PERIPHERAL EQUIPMENT DIVISION

TITLE <i>IMPROVE AIR CLEANINESS IN DISK CAVITY</i>			PIB NO. <i>DK3073B</i>		
PRODUCT LINE:	TAPE DISK FORMATTER <i>x</i>	EQUIPMENT CHANGED <i>Lower Disk Cover</i>	MODEL SERIES AFFECTED <i>D3XXX</i>	EFFECTIVE DATE <i>2/1/78</i>	
CLASS OF BULLETIN:		ORDER PART KIT NO.	EFFECTIVITY		
<input checked="" type="checkbox"/> IMPROVEMENT		<i>108120-01</i>	<i>All D3000 Top and Front Load with Part No. 904xxx-xx; 905xxx-xx. Excluding the D3000 Extension.</i>		
<input type="checkbox"/> RETROFIT ON FAILURE		TIME REQUIRED			
<input checked="" type="checkbox"/> RETROFIT RECOMMENDED		<i>¼ Hr.</i>			
<input type="checkbox"/> SERVICE INFORMATION ONLY					
PURPOSE:					
<i>To inform Disk customers that baffling the head opening port is an effective technique to pressurize the Disk cavity, therefore reducing contamination.</i>					
SYMPTOMS:					
<i>Excessive head crashes contributed to environments not complying to "clean room" standards.</i>

TITLE *IMPROVE AIR CLEANINESS IN DISK CAVITY*

PIB NO.
DK3073B

(FIGURE 1)

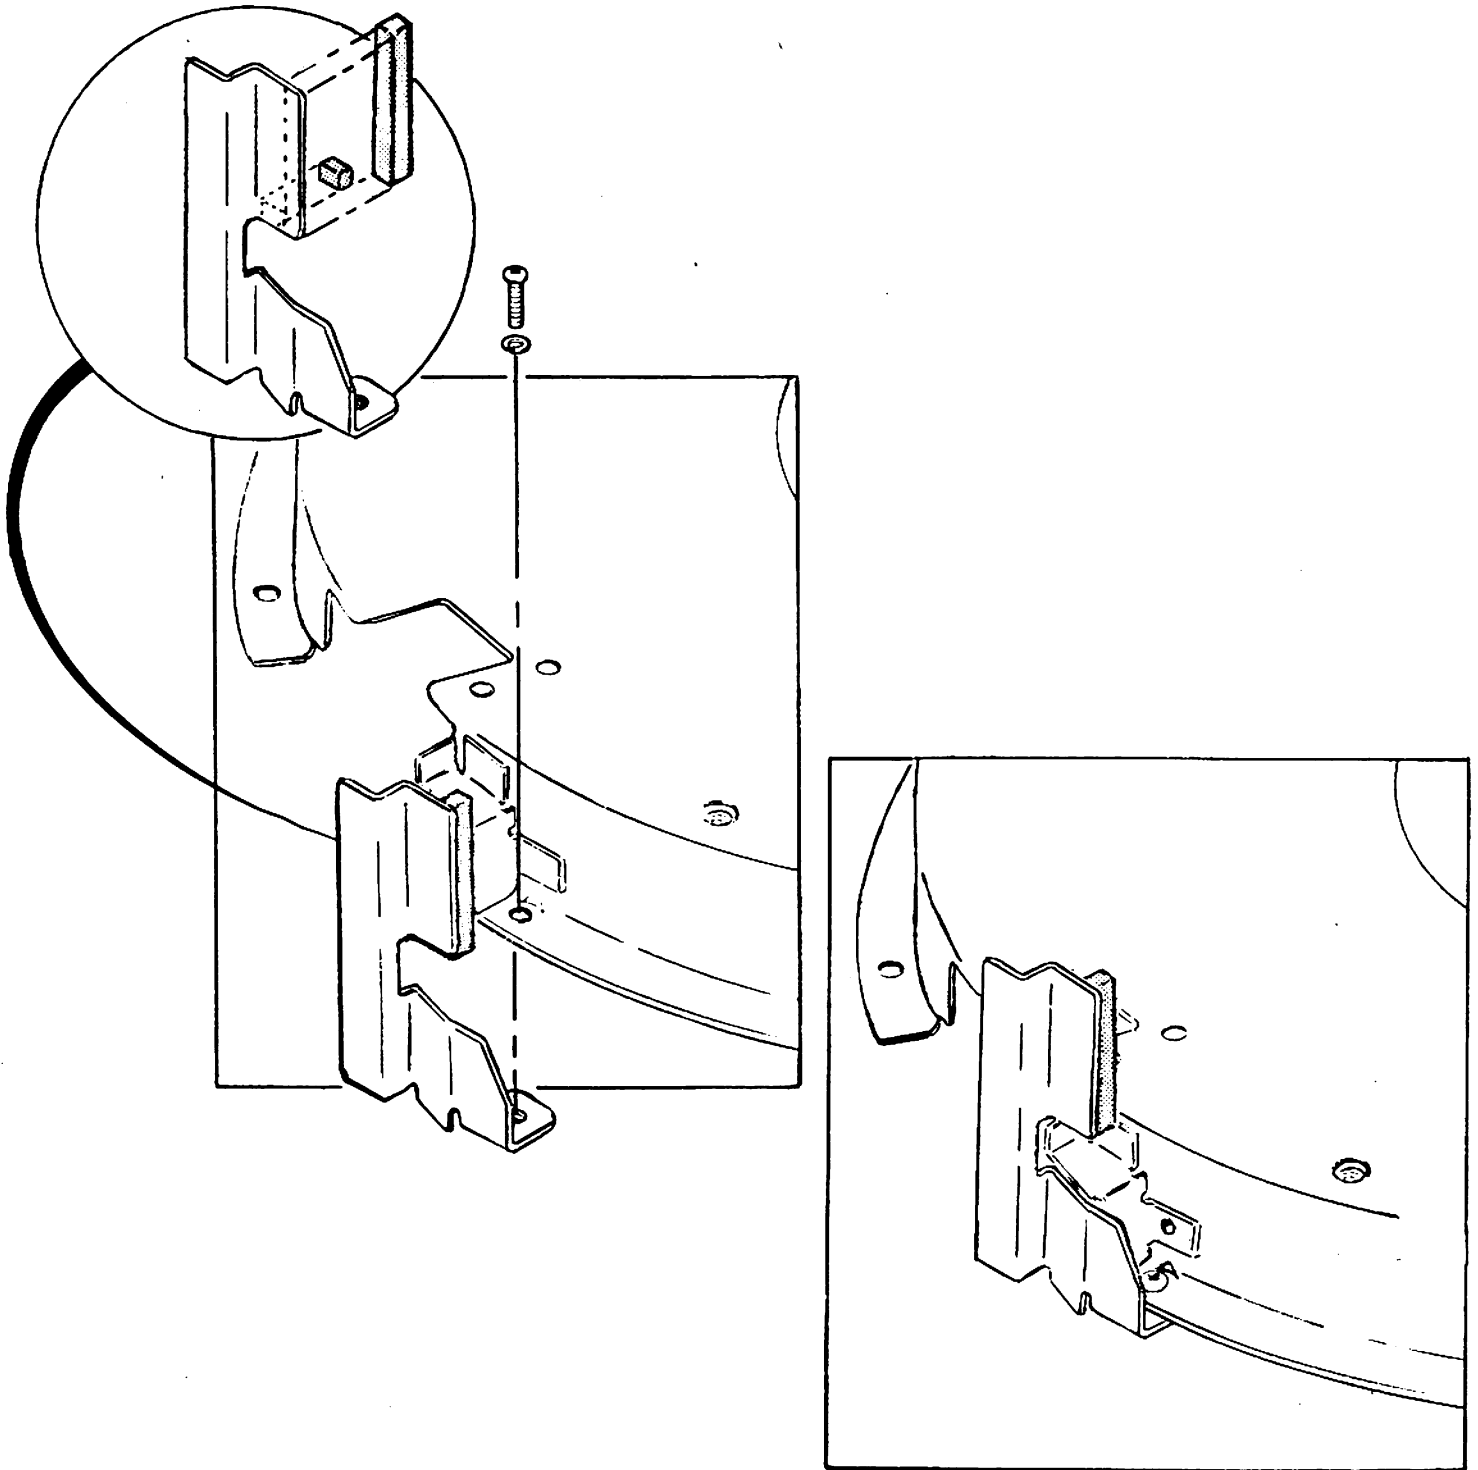
PARTS REQUIRED:					
	<u>QTY</u>	<u>Nomenclature</u>	<u>PERTEC P/N</u>		
	<i>1</i>	<i>Baffle Kit Assy.</i>	<i>108120-01</i>		
<i>Note: Price is \$5.00 per kit, non-discountable through normal spare part channels.</i>					
INSTALLATION PROCEDURE: (See figure 1)

1) Remove power from unit.					
2) Raise Logic PCBA.					
3) Locate Hole in lower Disk Cover adjacent to white Disk Guide.					
4) Install Baffle as per Figure 1.

a. Slip lower lip of baffle underneath the hole located in step 3.					
5) Install phillips head screw (10-32X5/16) with lock washer.					
ADJUSTMENTS:

1) Bending and or adjustment of the Baffle may be necessary to ensure a snug fit of the foam against the Lower Disk Cover.					
2) Verify that the Bail Door Opener (P/N 102624) can be moved throughout its range without interference.
